Access Compliance Report Public Rights-of-Way (Curb Ramps)

Main Street: BRAMFORD_RD Cross Street: WALDEN_ST Location: NW

ADA ID: RPRK211020172942 Ramp Type: Type 4 - Parallel Initial Pass/Fail: Fail Overall Compliance: No Severity Score: 16

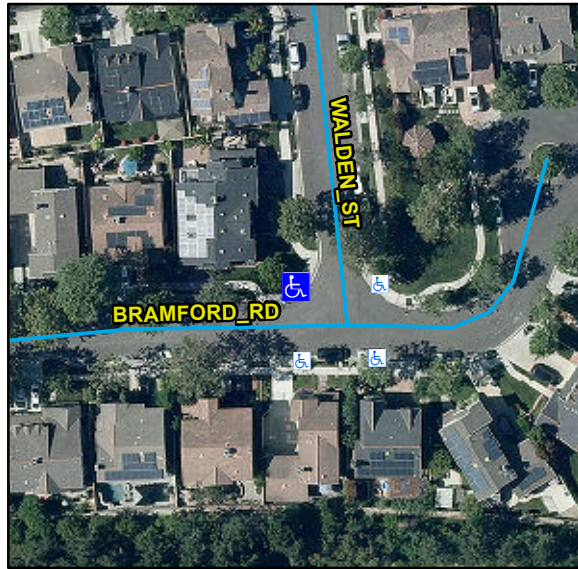
Compliance	Description	Data	Compliance	Description	Data
N/A	Ramp Length LT (in)	115	N/A	Ramp Length RT (in)	116
Yes	Ramp Width LT (in)	53	Yes	Ramp Width RT (in)	54
Yes	Ramp Run Slope LT (%)	0.8	No	Ramp Run Slope RT (%)	8.8
No	Ramp Cross Slope LT (%)	4.1	Yes	Ramp Cross Slope RT (%)	0.8
N/A	Landing Present	N/A	N/A	DWS Provided	N/A
N/A	Landing Length (in)	N/A	N/A	DWS Contrast	N/A
N/A	Landing Width (in)	N/A	N/A	DWS Length (in)	N/A
N/A	Landing Run Slope (%)	N/A	N/A	DWS Full Width	N/A
N/A	Landing Cross Slope (%)	N/A		DWS Offset Type	N/A
N/A	Landing Movement Obstructed?	N/A	N/A	DWS Offset Left (in)	N/A
	Landing Movement Type	N/A	N/A	DWS Offset Right (in)	N/A
N/A	Landing Shared	N/A			
N/A	Clear Space	Yes			
N/A	Clear Space To Crosswalk (in)	N/A			
N/A	Marked Crosswalk 1	No	N/A	Marked Crosswalk 2	No
	Crossing 1 Direction	S		Crossing 2 Direction	E
	Marked Crosswalk 1 Width (in)	N/A		Marked Crosswalk 2 Width (in)	N/A

Remove & Replace Curb Ramp With Two New Directional Ramps or Equivalent.
